LOCAL HISTORIC DISTRICT: Dilworth

PROPERTY ADDRESS: 708 East Tremont Avenue

SUMMARY OF REQUEST: Addition

Revised Proposal – May 8

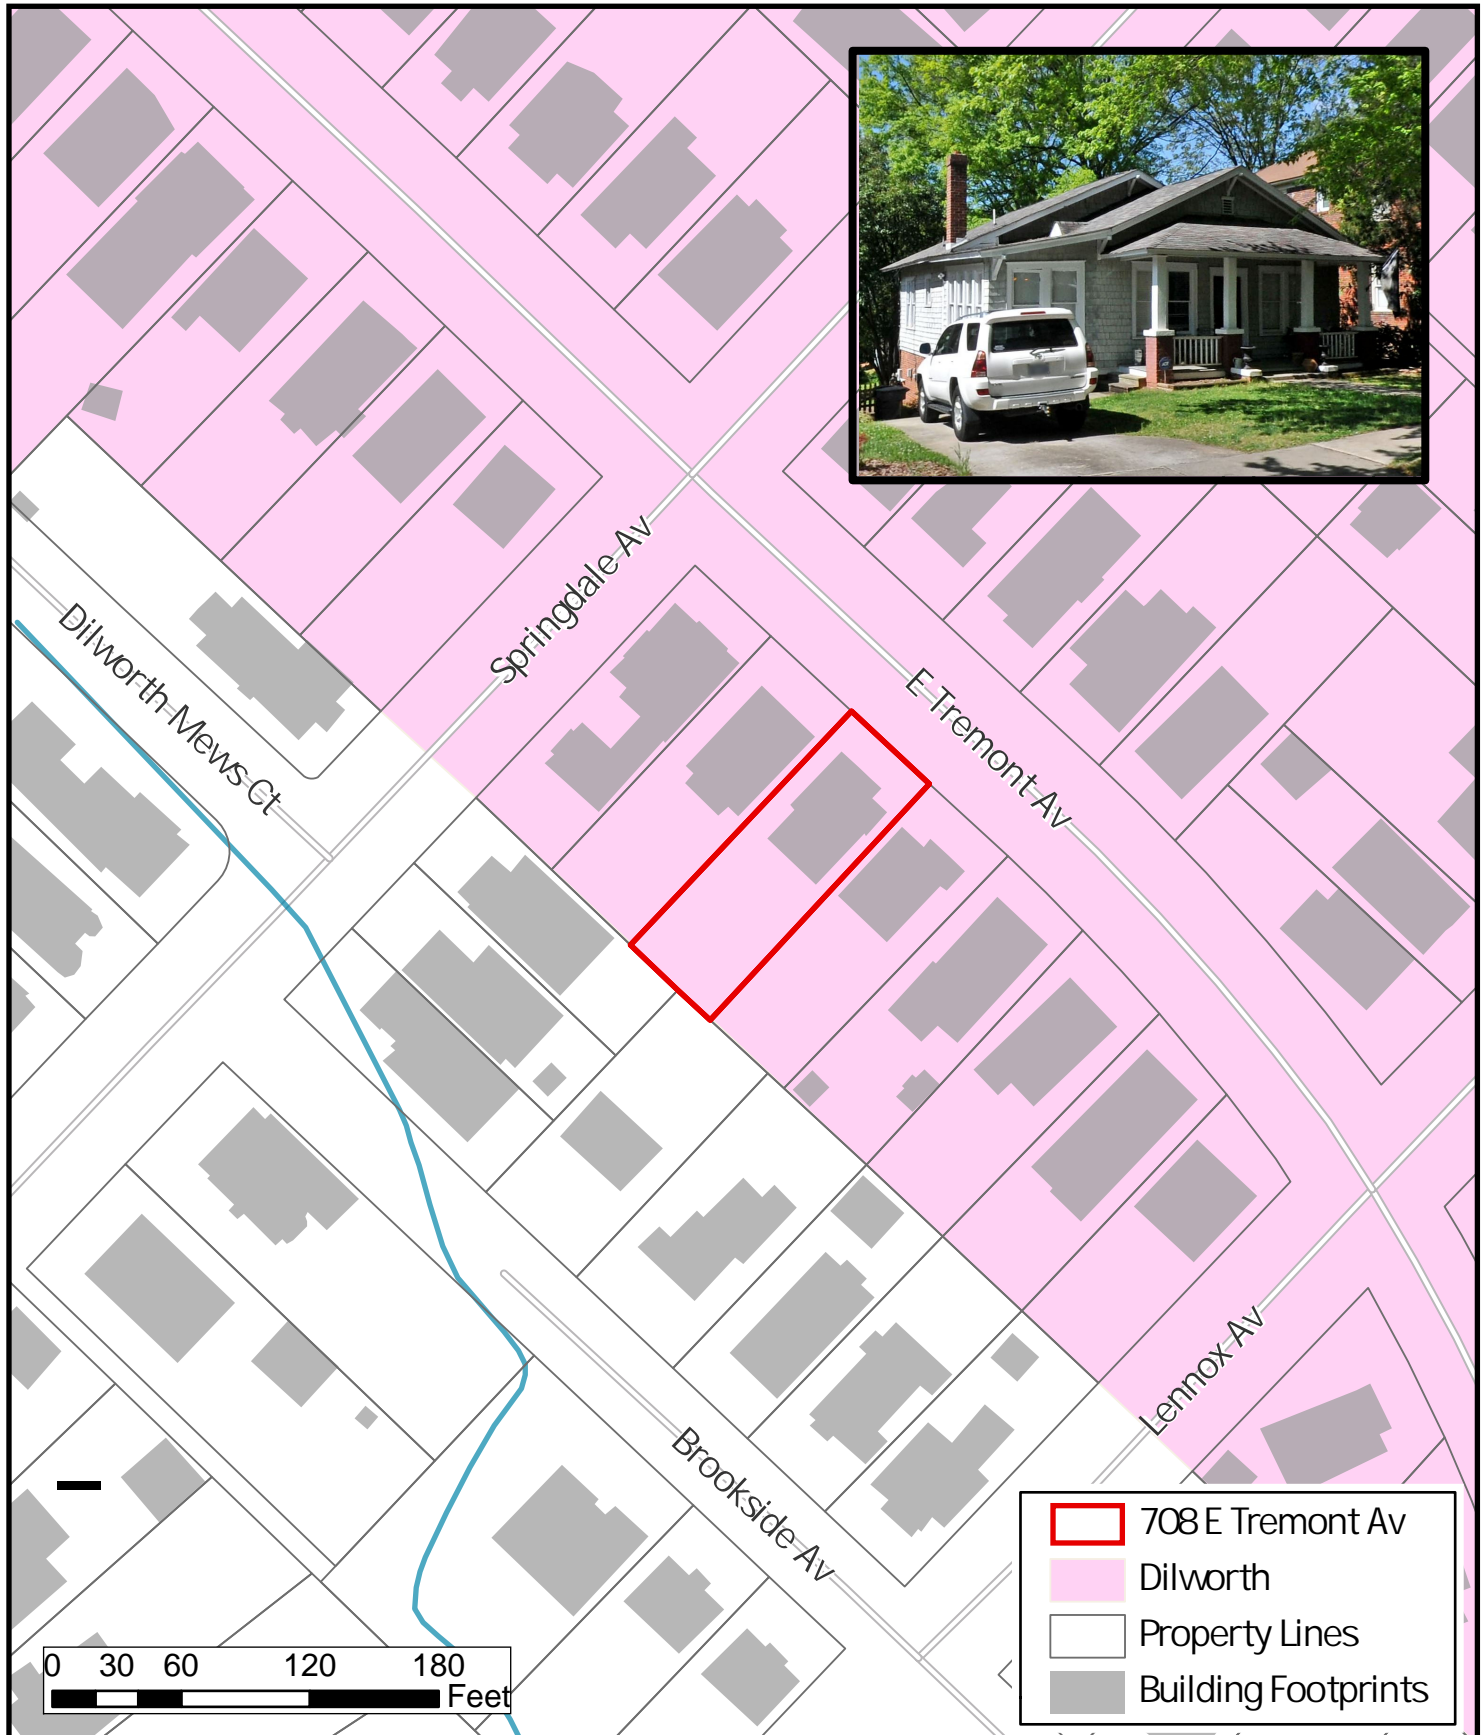
1. Fenestration changed to match the historic windows.
2. Added fenestration to right side of the addition.
3. Rear columns and trim changed to match existing.
4. Tree protection plan provided.

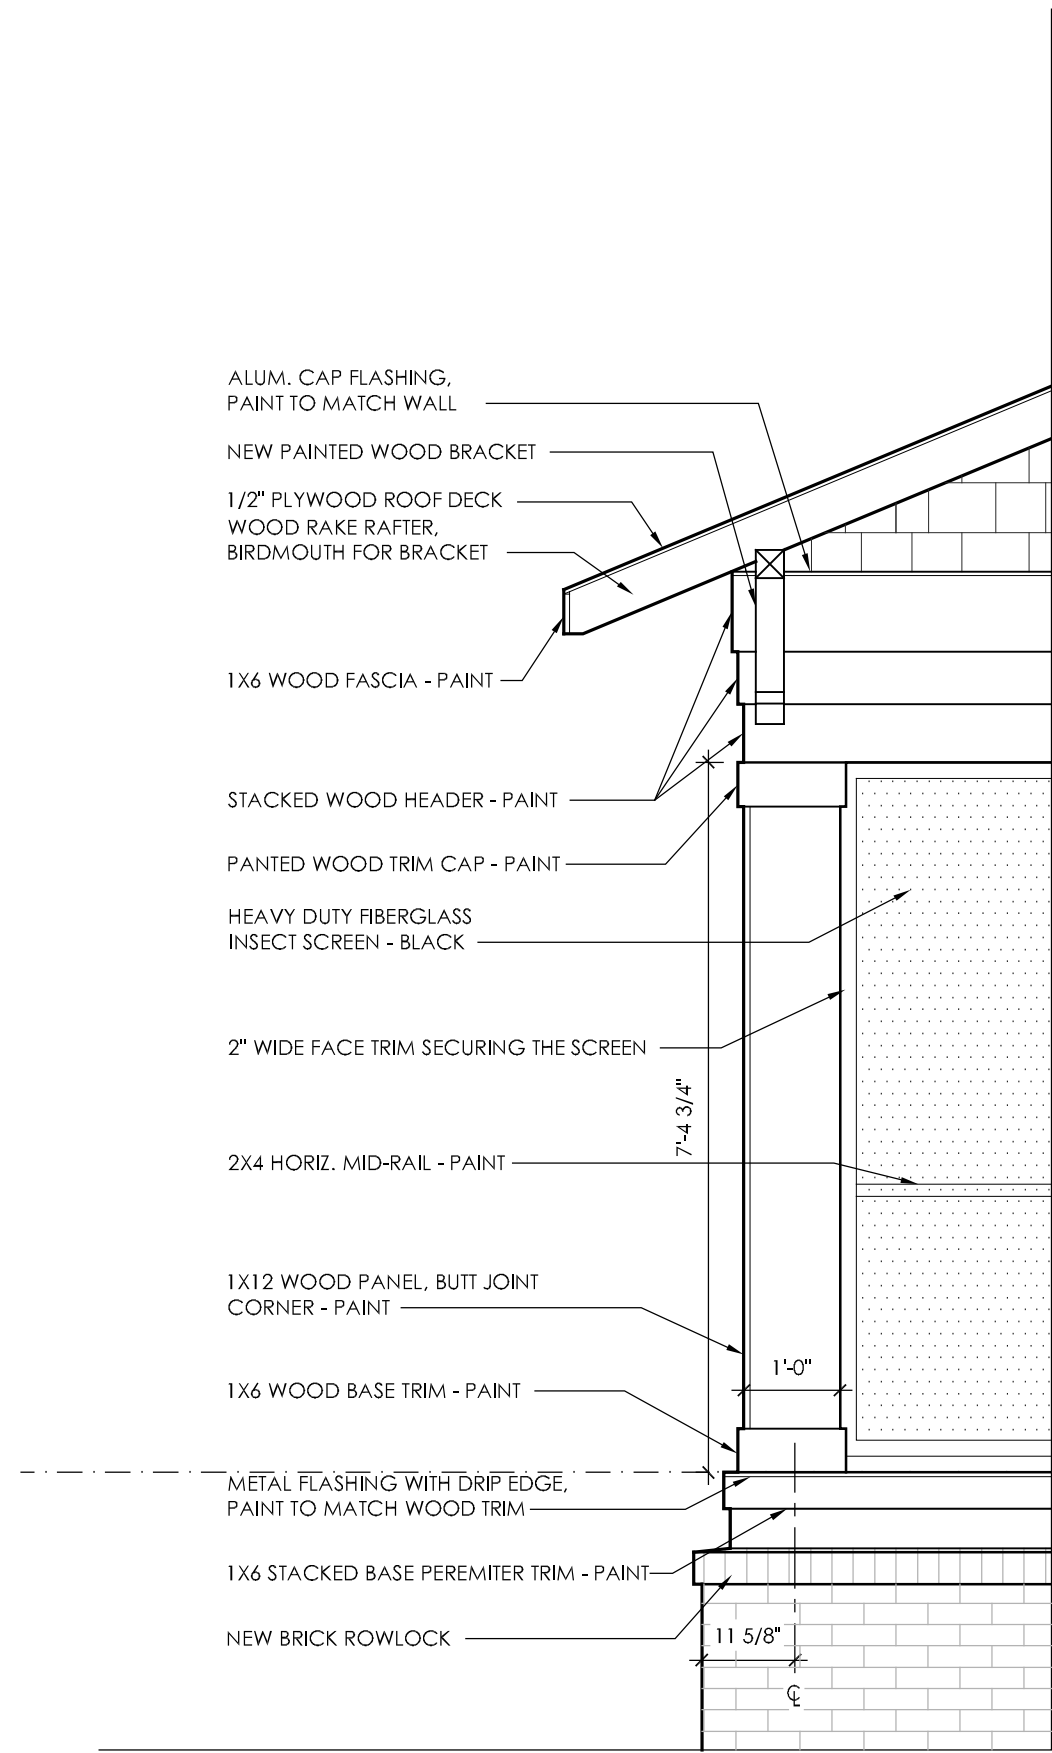
WHAT WOULD APPEAR TO BE A PORCH THAT WAS ENCLOSED AT SOME POINT HAS FOUNDATION ISSUES AND HAS DROPPED APPROX. 5" BELOW FINISHED FLOOR. NOT KNOWING THE EXTENT OF THE REQUIRED REPAIR TO LEVEL THE EXISTING STRUCTURE, SOME OR POSSIBLY COMPLETE DEMOLITION OF THIS PORCH ELEMENT MAY BE NECESSARY. THE INTENT IS TO RESTORE THIS ELEMENT TO A SAFE AND STABLE STRUCTURE. IF RECONSTRUCTION IS REQUIRED, IT WILL MATCH THE EXISTING.

SCALE: 1/4" = 1'-0" REVISED PROPOSED FRONT ELEVATION 02

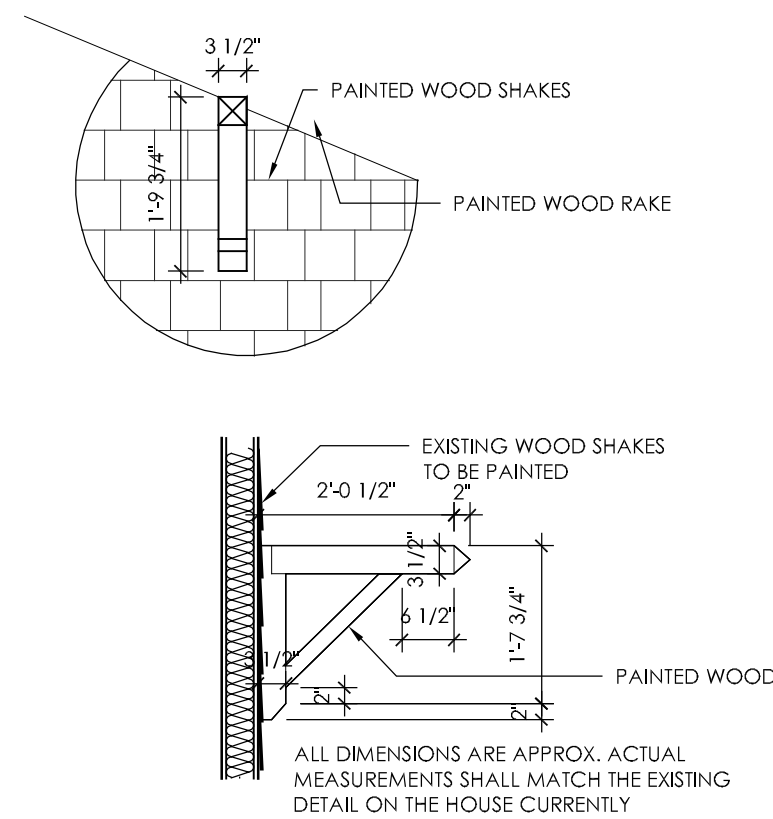
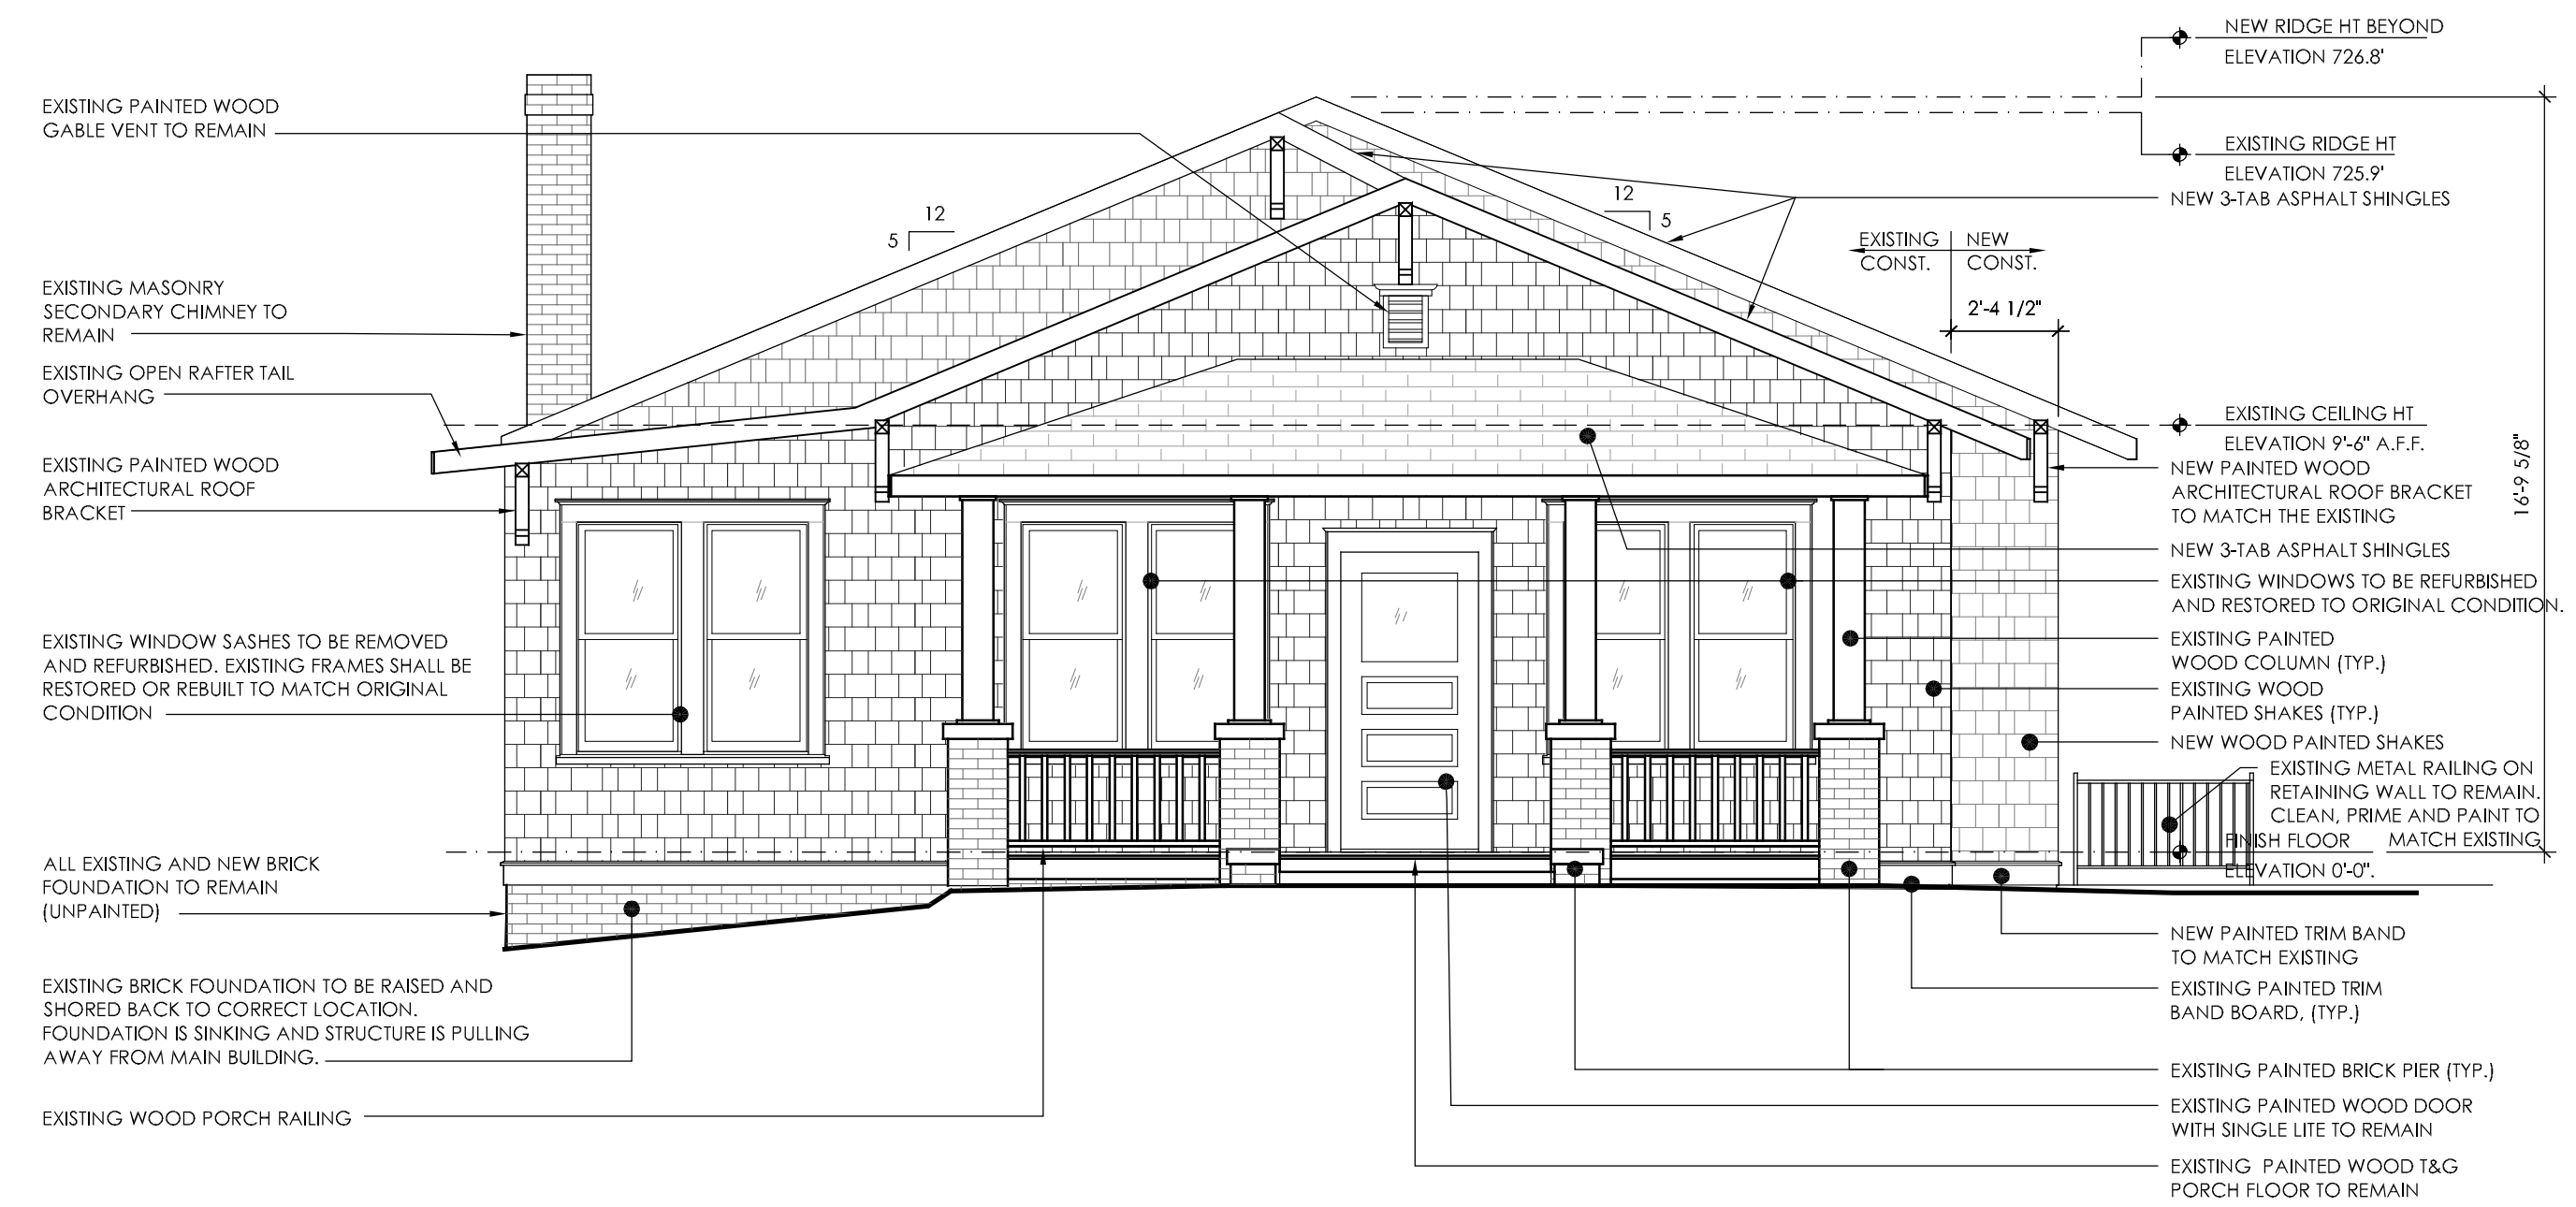
- 1. Windows, page 4.4, item 1:** Retain original windows double ganged windows to the immediate left of the chimney. New windows should match style and dimension of the original.
- 2. Windows, page 4.4, item 8:** Repair windows to match the same dimensions as original.
- 3. Doors and Windows, page 6.12, item 1:** Revisit fenestration on the right side of the addition.
- 4. Bungalows, page 3.16 and Trim, page 4.11:** Rear columns and trim to match dimensions on the front.
- 5. Trees, page 8.5, item 4:** Provide a tree protection plan.
